Seismic Walkdown Checklist (SWC)

Equipment ID No. H21P081 Equip. Class¹ 18, Instrument Racks

Equipment Description Div 2 EECS Trip Unit Instrument Rack

NJPR-12-0043

Seismic Walkdown "Hand Sketch"

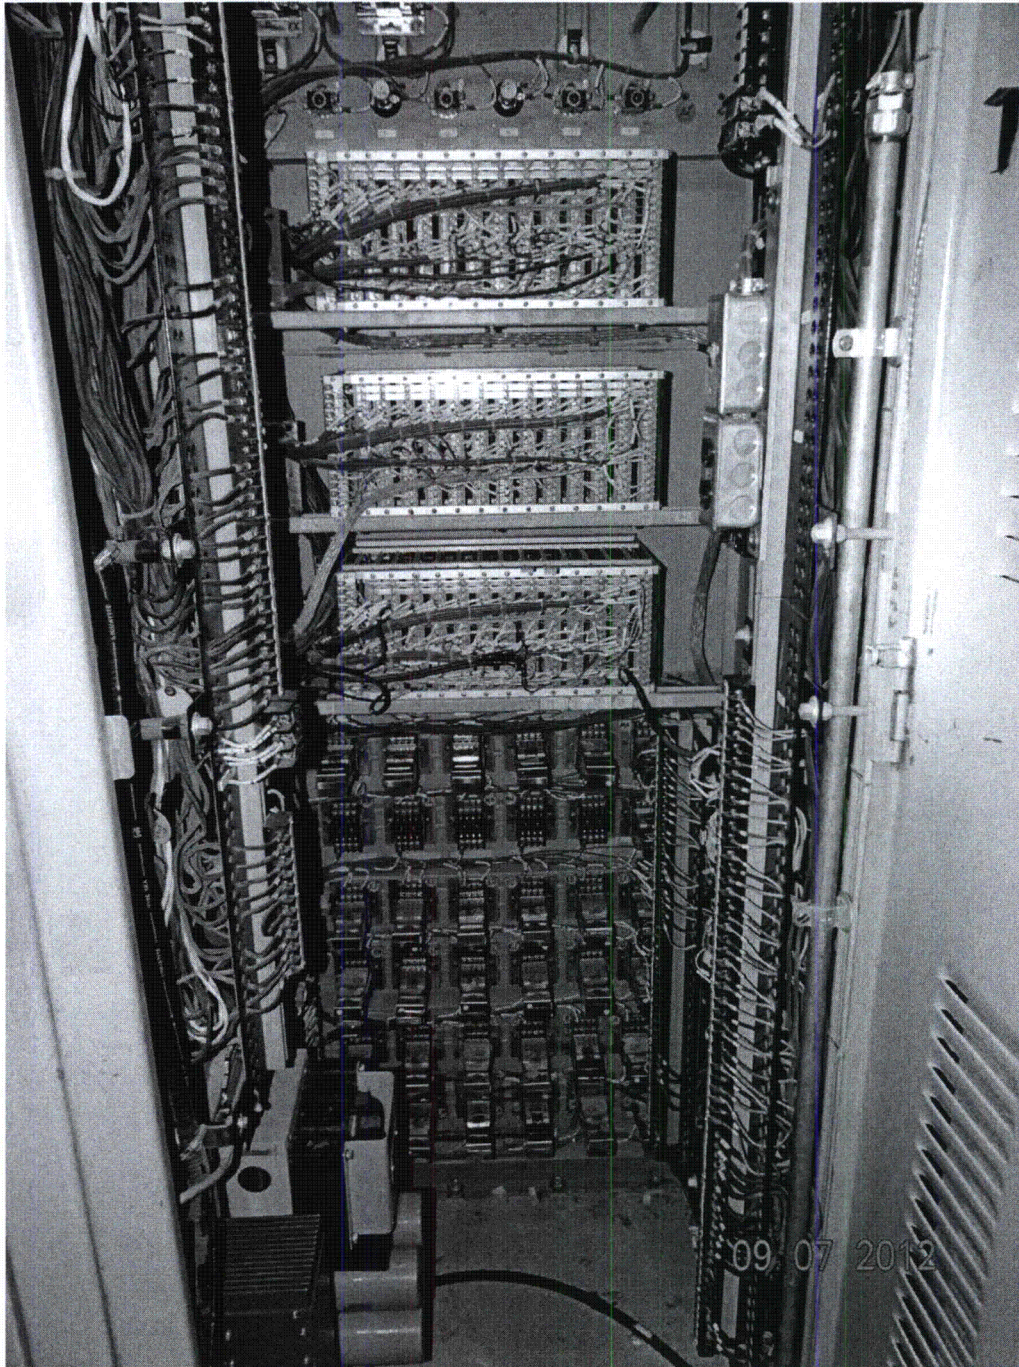
1. Is the anchorage configuration verification required (i.e., is the item one of the 50% of SWEL items requiring such verification)? Y N
2. Is the anchorage free of bent, broken, missing or loose hardware? Y N U N/A
There are no Bent, Broken, Missing or loose bolts. However, only one anchor bolt has full thread engagement per Fermi Spec. 3071-226, Rev. K, Section 3.3.5.4(b). See attached "Hand sketch". Card 12-27702 was initiated to resolve this matter.

6. Based on the above anchorage evaluations, is the anchorage free of potentially adverse seismic conditions? Y N U
All but the bottom three cabinet-to cabinet bolts in the northeast corner of H21P081 are viewable from the H21P083 side (see photo DSC01157). All anchor bolts were visible and only one anchor bolt had full thread engagement (at least one thread exposed from face of nut) per Spec. 3071-226. CARD 12-27702 was initiated.

Seismic Walkdown "Hand Sketch"

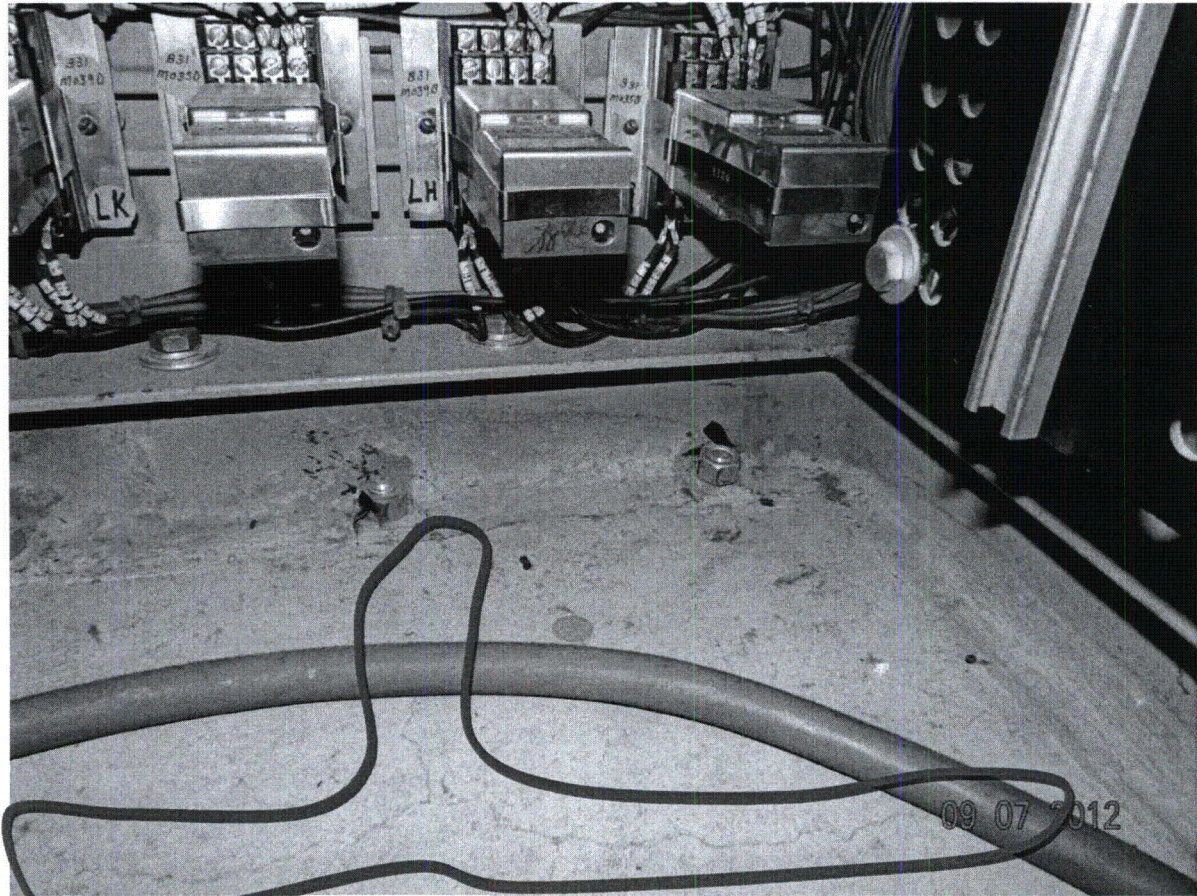
1. Is the anchorage configuration verification required (i.e., is the item one of the 50% of SWEL items requiring such verification)? Y N
2. Is the anchorage free of bent, broken, missing or loose hardware? Y N U N/A
No Broken, Missing or loose bolts. Thread engagement on five anchor bolts is less than one thread exposed from face of nut per Fermi Spec. 3071-226, Rev. K, Section 3.3.5.4(b). See attached "Hand sketch". Card 12-27702 was initiated to resolve this matter.

6. Based on the above anchorage evaluations, is the anchorage free of potentially adverse seismic conditions? Y N U
Item (2) - Five anchor bolts do not have full thread engagement per Fermi spec. 3071-226. Anchor bolt in northwest corner of cabinet has a flat washer instead of a beveled washer. See attached "Hand sketch". (see photo DSC01140). CARD 12-27702 was initiated. Bottom, southwest cabinet to cabinet bolt not visible due to wires in cabinet.

(DSC01136)

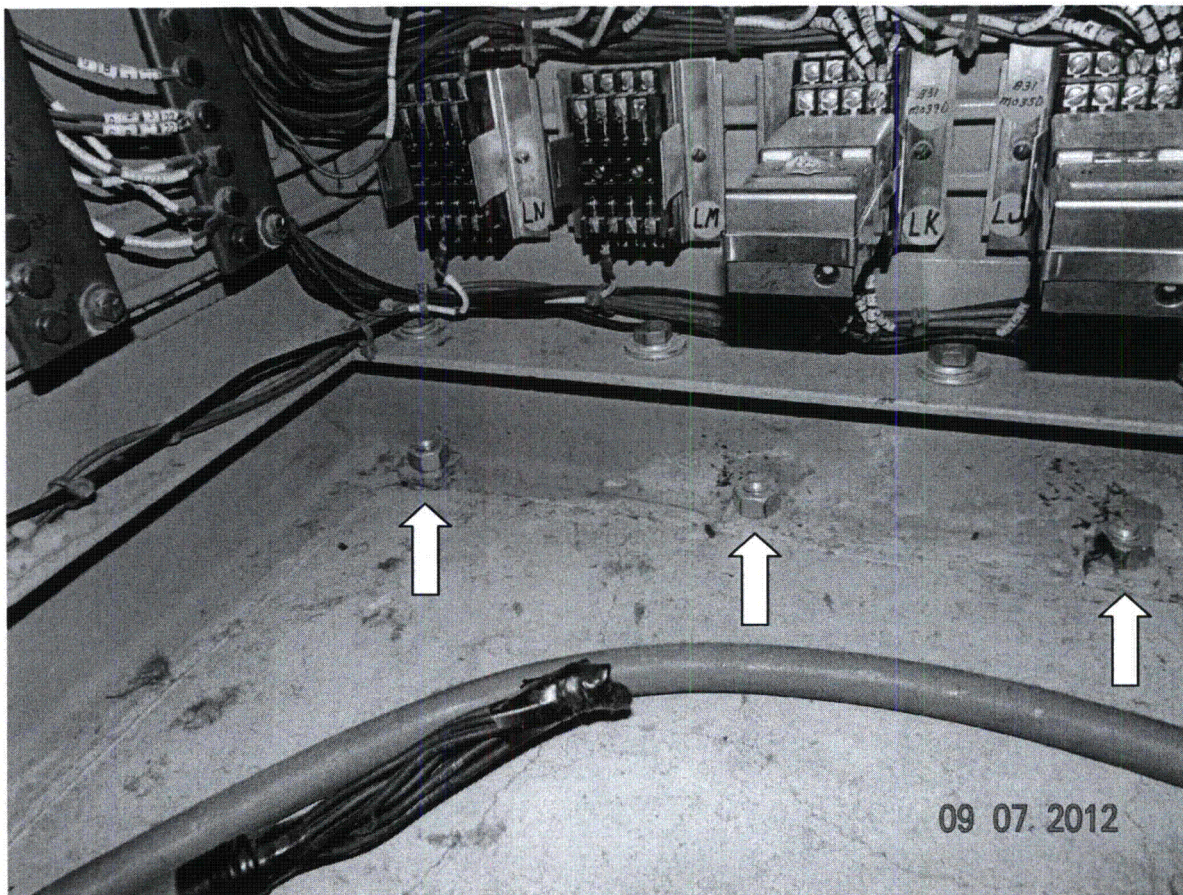
3. Is the anchorage free of corrosion that is more than mild surface oxidation? Y N U N/A
No corrosion or oxidation inside the cabinet.
4. Is the anchorage free of visible cracks in the concrete near the anchors? Y N U N/A
Minor hairline cracks visible within 1" of anchor bolt. See attached "Hand sketch". The cracks are "Shrinkage" cracks and not cause for concern (see photo DSC01136).

(DSC01144)

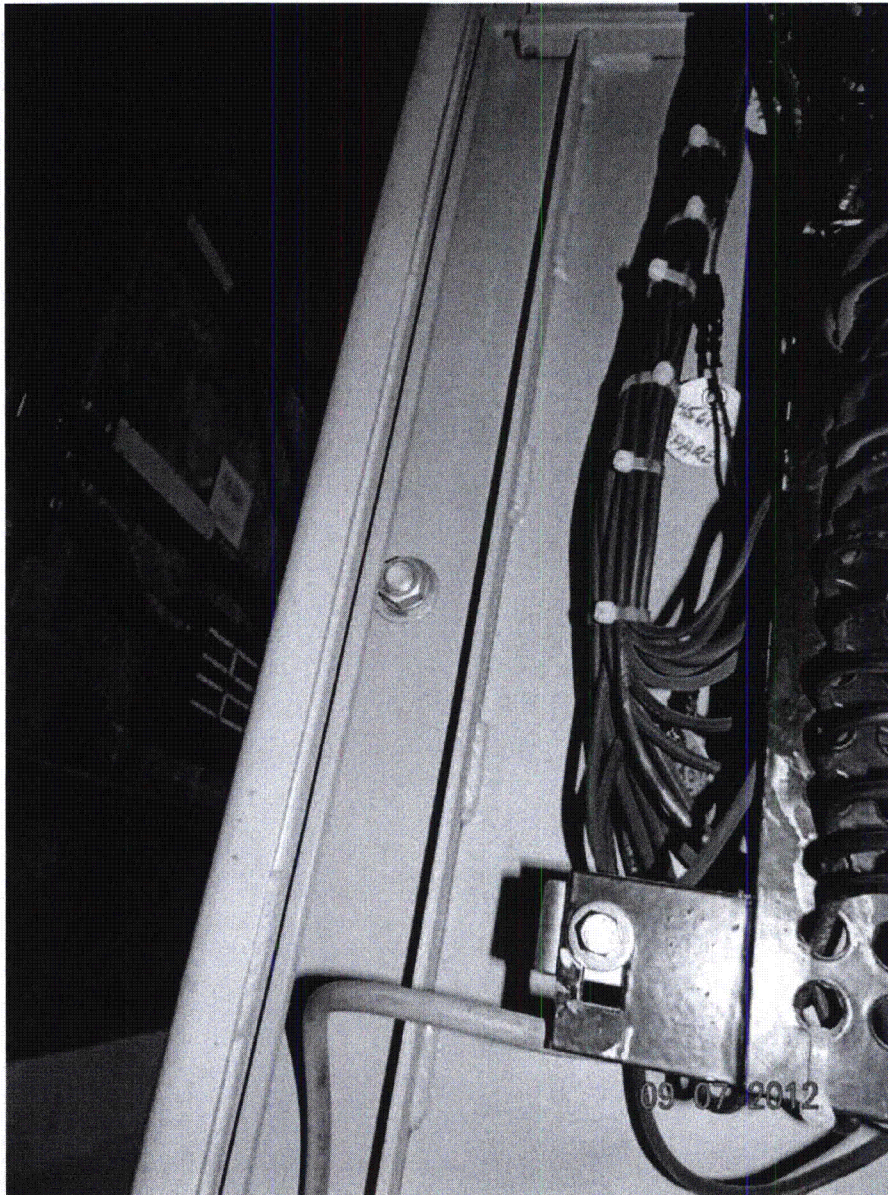
10. Based on the above seismic interaction evaluations, is equipment free of potentially adverse seismic interaction effects? Y N U
The equipment is free of potential adverse seismic interaction effects. The adjacent cabinets are bolted together side by side. No possibility of banging into each other (see photos DSC01144, 01147, 01150 & 01153).

Seismic Walkdown "Hand Sketch"

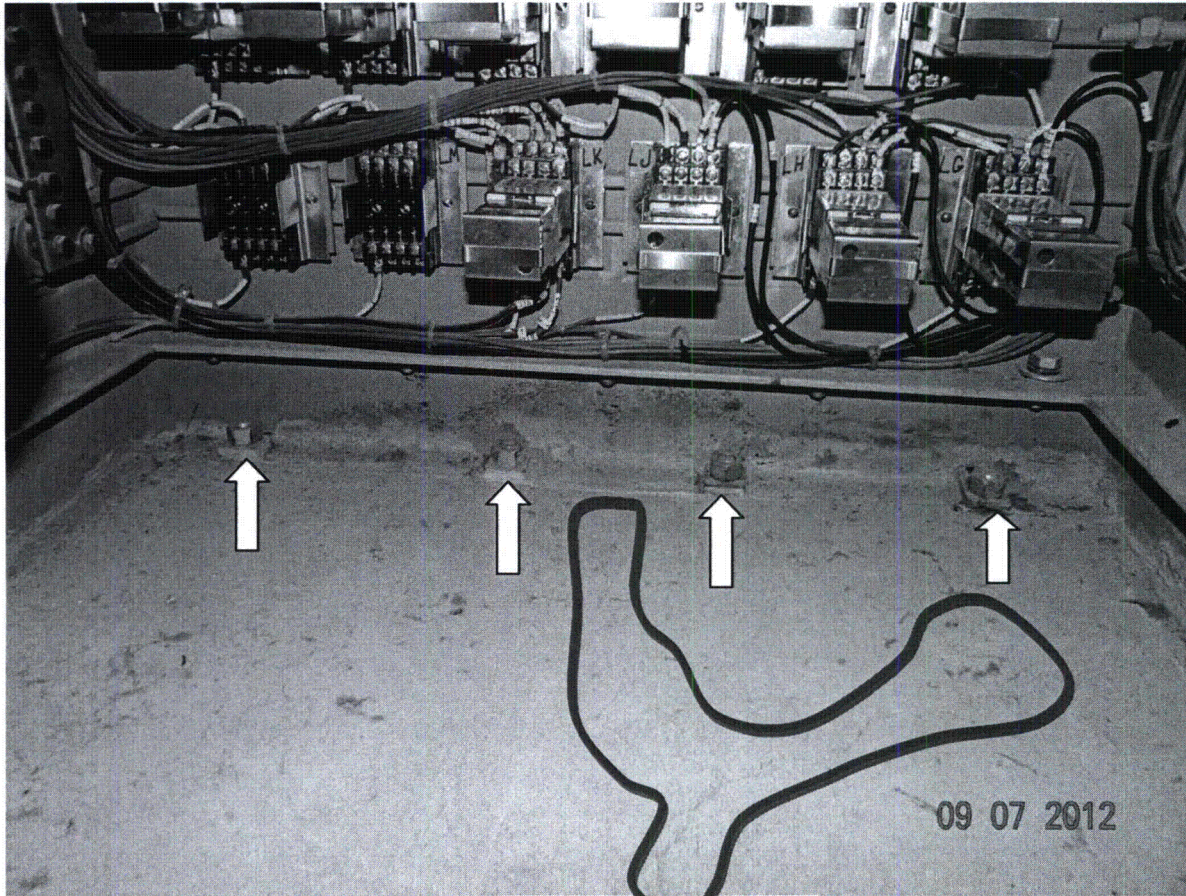
1. Is the anchorage configuration verification required (i.e., is the item one of the 50% of SWEL items requiring such verification)? Y N
2. Is the anchorage free of bent, broken, missing or loose hardware? Y N U N/A
All bolts correct size, acceptable spacing, and appear tight. Thread engagement on five anchor bolts is less than one thread exposed from face of nut per Fermi Spec. 3071-226, Rev. K, Section 3.3.5.4(b). See attached "Hand sketch". Card 12-27702 was initiated to resolve this matter.

6. Based on the above anchorage evaluations, is the anchorage free of potentially adverse seismic conditions? Y N U
Item (2) - Five anchor bolts do not have full thread engagement per Fermi spec. 3071-226. CARD 12-27702 was initiated to resolve this matter.

(DSC01116)

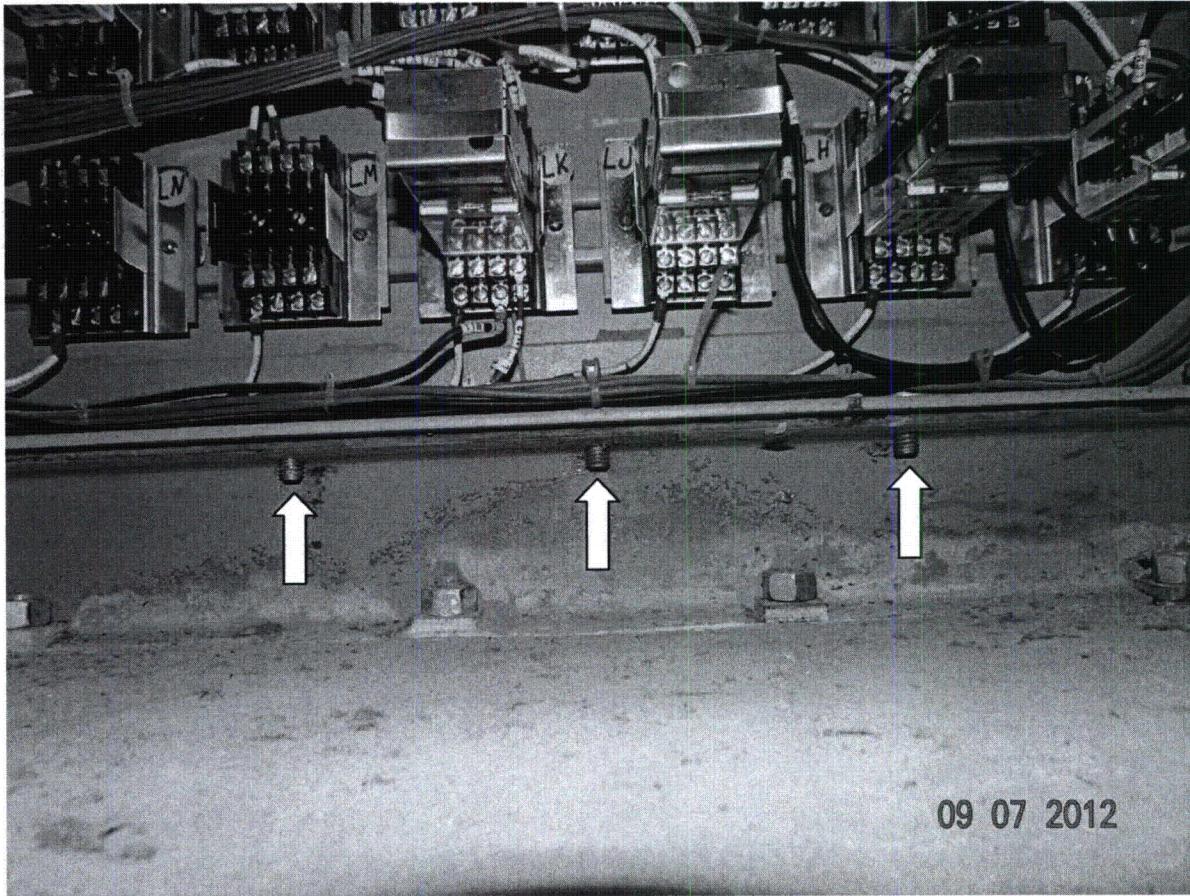
3. Is the anchorage free of corrosion that is more than mild surface oxidation? Y N U N/A
All bolts are corrosion-free or painted.
4. Is the anchorage free of visible cracks in the concrete near the anchors? Y N U N/A
Minor hairline cracks between anchors. The crack is a "Shrinkage" crack and not cause for concern. (see photo DSC01116)

(DSC01126)

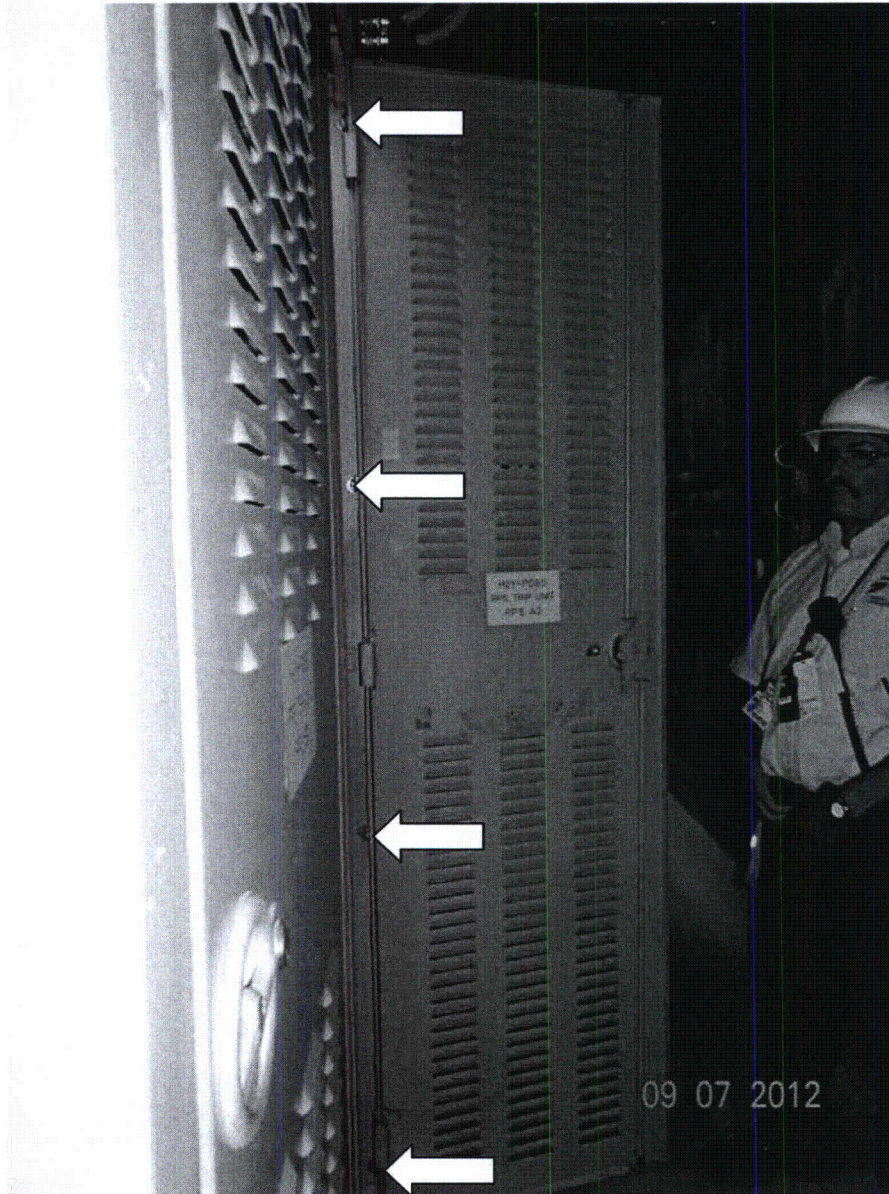
7. Are soft targets free from impact by nearby equipment or structures? Y N U N/A
Due to enclosed cabinet, no potential exists for impact with in the cabinet.
8. Are overhead equipment, distribution systems, ceiling tiles and lighting, and masonry block walls not likely to collapse onto the equipment? Y N U N/A
No ceiling tiles. Lights seismically supported and over 1'-0" away. Overhead systems and block walls are seismically supported.
9. Do attached lines have adequate flexibility to avoid damage? Y N U N/A
All Conduits are flex conduits with ample flexibility.
10. Based on the above seismic interaction evaluations, is equipment free of potentially adverse seismic interaction effects? Y N U
Adjacent cabinets are bolted together side by side to prevent banging into each other, thus cabinets are free of potentially adverse seismic interaction effects. (see photos DSC01118, 01126 & 01128)

Seismic Walkdown "Hand Sketch"

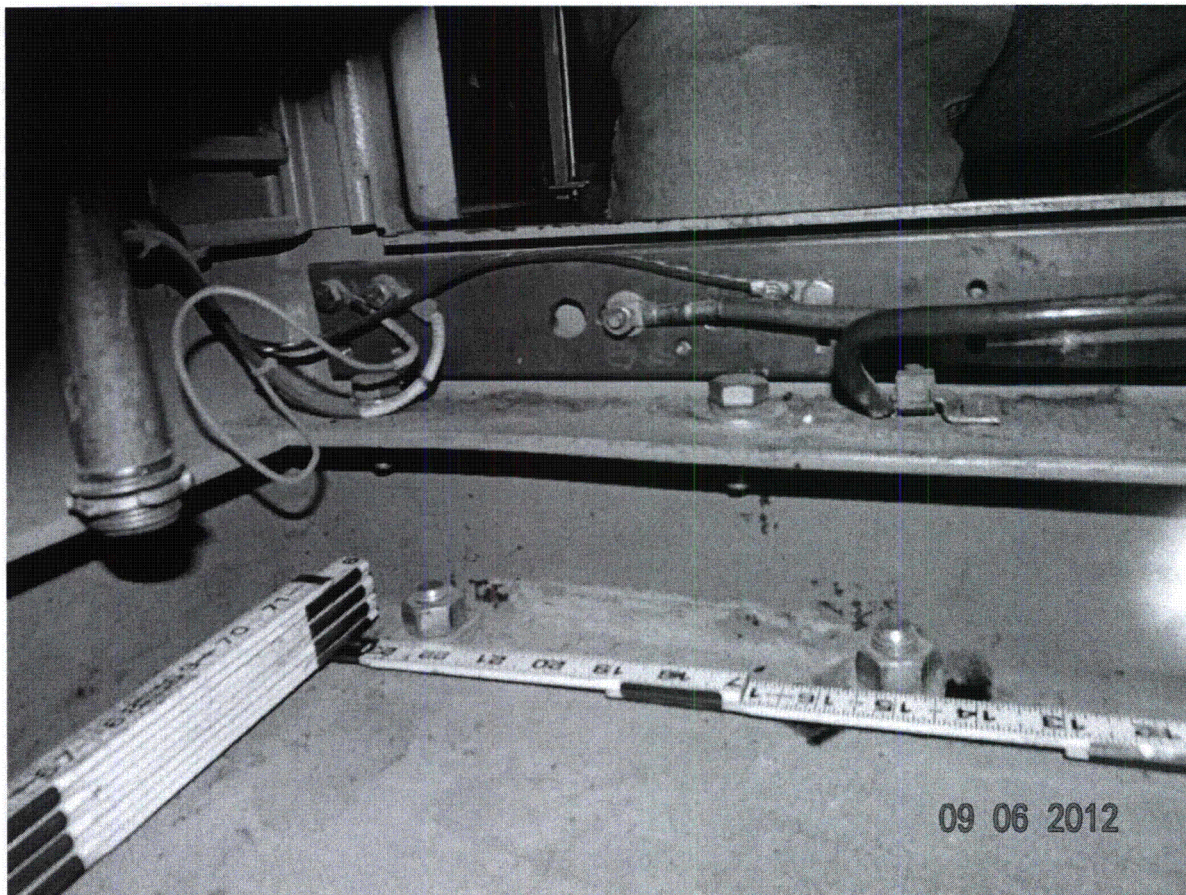
1. Is the anchorage configuration verification required (i.e., is the item one of the 50% of SWEL items requiring such verification)? Y N U
2. Is the anchorage free of bent, broken, missing or loose hardware? Y N U N/A
Thread engagement on some anchor bolts is less than one thread exposed from face of nut per Fermi Spec. 3071-226, Rev. K, Section 3.3.5.4(b). See attached "Hand sketch". Card 12-27702 was initiated to resolve this matter. Also, one bolt has a flat round washer instead of a square beveled washer (see photo DSC01090).

6. Based on the above anchorage evaluations, is the anchorage free of potentially adverse seismic conditions? Y N U
Item (2) - Some anchor bolts do not have full thread engagement per Fermi spec. 3071-226. & one bolt has a round washer instead of beveled washer. See attached "Hand sketch". CARD 12-27702 was initiated to resolve both issues (see photo DSC01090).
